Reference: Bioscience and Technology Business Center  
West Facility  
Located on Bob Billings Parkway - Lawrence, Kansas

## 4950 Research Parkway

### Existing Roof Report and Budgets to Replace

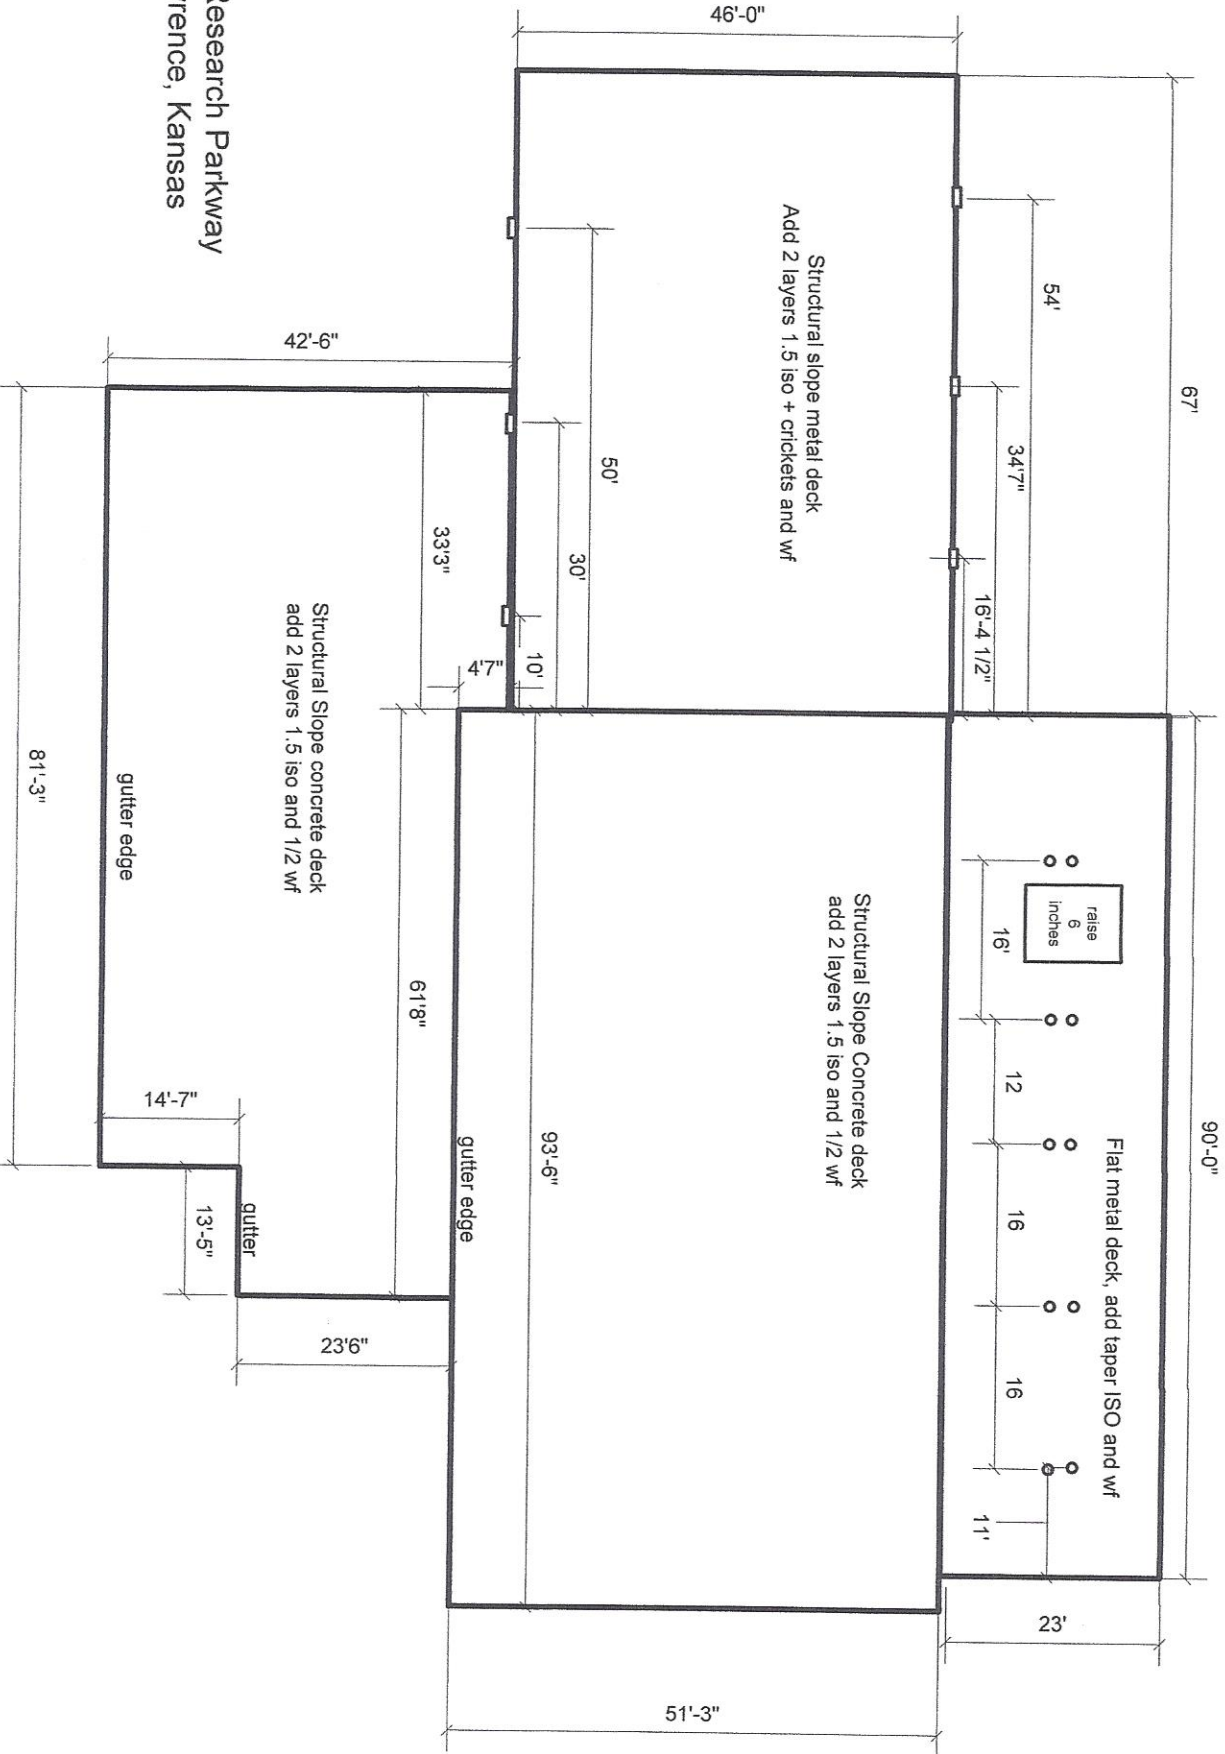
With the roof study that was completed; the walls above the roof were also inspected at this time. Several items were found with wall details that will also need to be addressed at the time the roof is done to protect the new roof assembly.

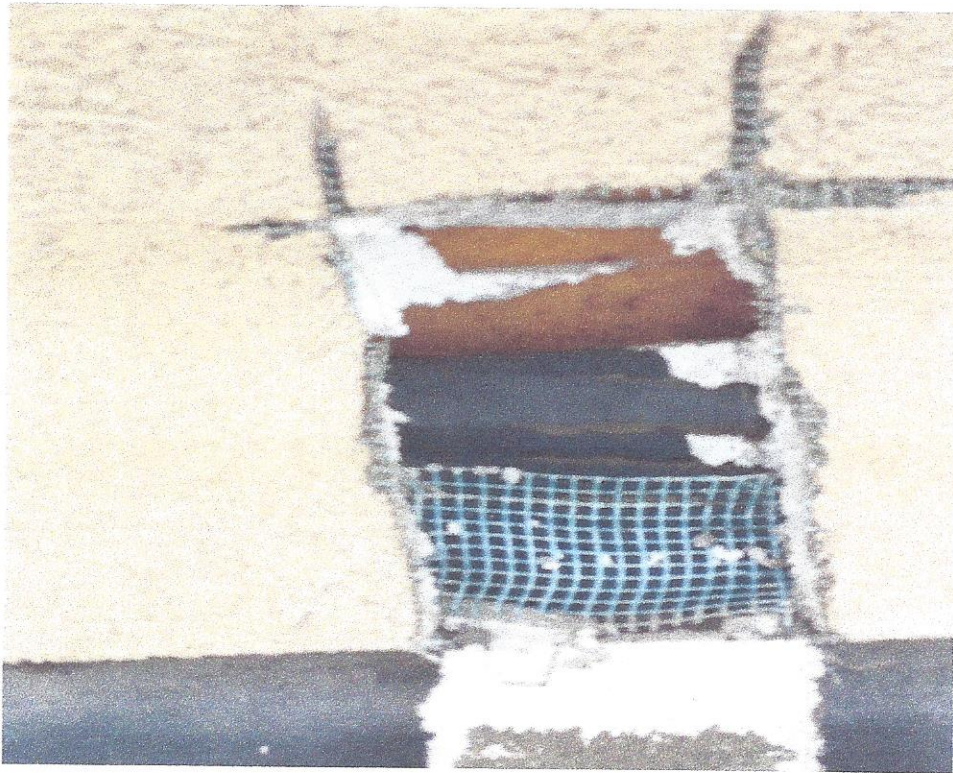
The ballasted EPDM roof was flashed up and under the EFIS (Exterior Finished Insulated System). The roof membrane was not secured to the back-up wall properly at the time of installation. With the shrinkage of the membrane; the EFIS wall covering was pulled away from the back-up wall and fractured the insulation in this assembly. As you can see in the photo, any water that get into the EFIS wall system will run down the back up wall and directly behind the roof membrane flashing and into the roof assembly and subsequently into the building.

At the very least, when a new roof assembly is installed, the EFIS system will have to be cut back a minimum of 10-12 inches above where the base of the system is currently. A second and better option would be to remove the EFIS system above the roof membrane areas and replace decorative insulated wall panels. This would eliminate needed repairs to the EFIS system in many areas around the facility.

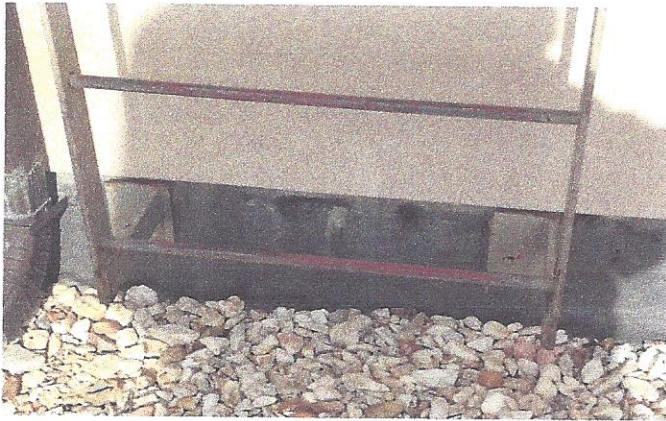
There are many areas around the EFIS wall assembly that are open and allowing water to enter the assembly. This also allows the insulation to get wet causing it to lose its insulating properties as well as freeze up in the winter causing further damage to the EFIS.

When secondary items were installed, mechanical fasteners were run directly through the base flashings of the membrane. This should never happen. These types of details would be corrected at the time of the new roof.

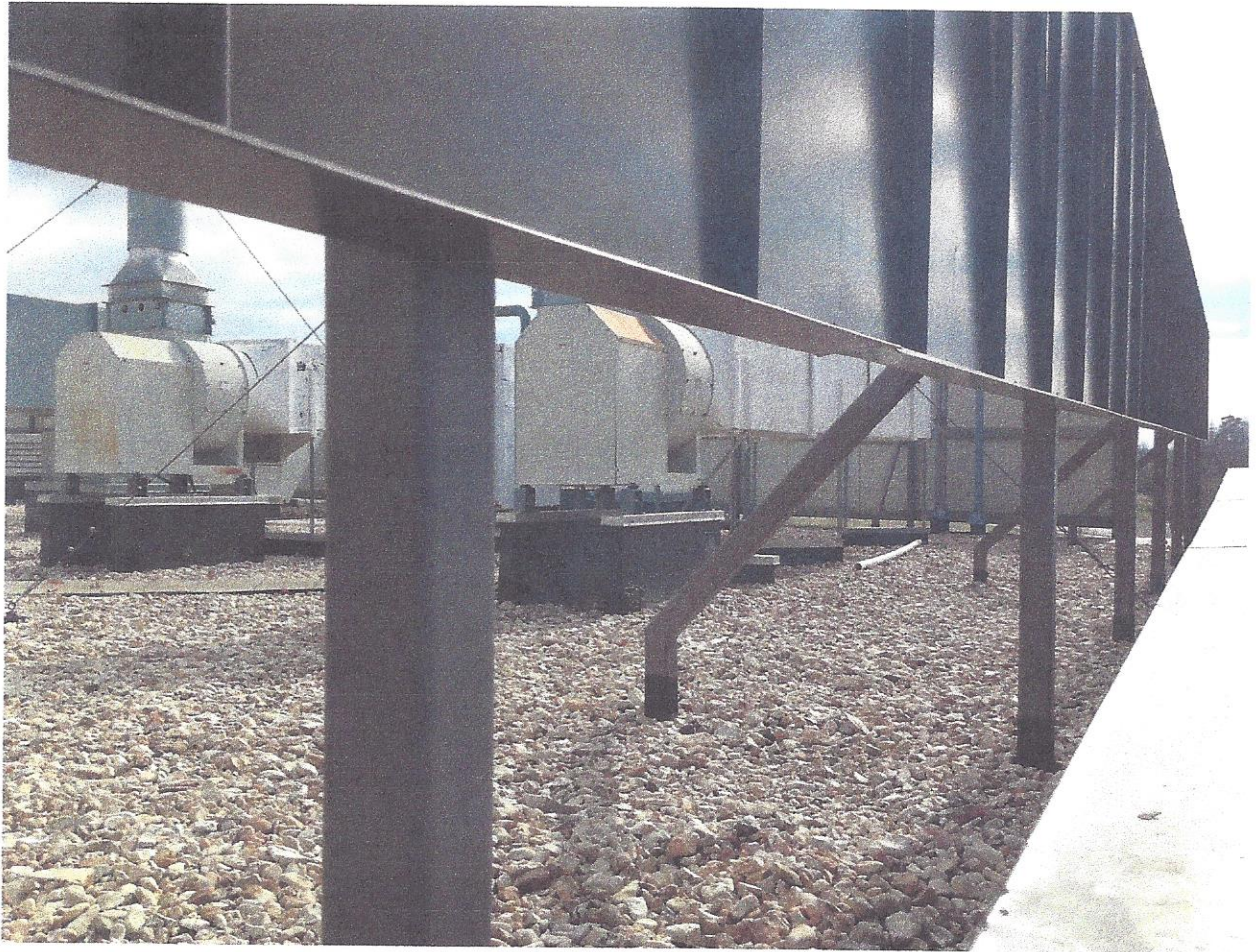
The short masonry wall on the south side of the facility appears to have the weep holes in the brick covered up by the existing roof; or they were never installed. This is another area where the interior could be showing up as a leak. It appears that someone attempted roof repairs on the membrane with an asphalt product that is not supposed to be used on this type of roof.

The mechanical unit on the north roof area is not high enough above the roof to flash properly. This unit would need to be raised about six to eight inches above the existing height. NRCA recommends that all mechanical curbs be a minimum of eight inches.
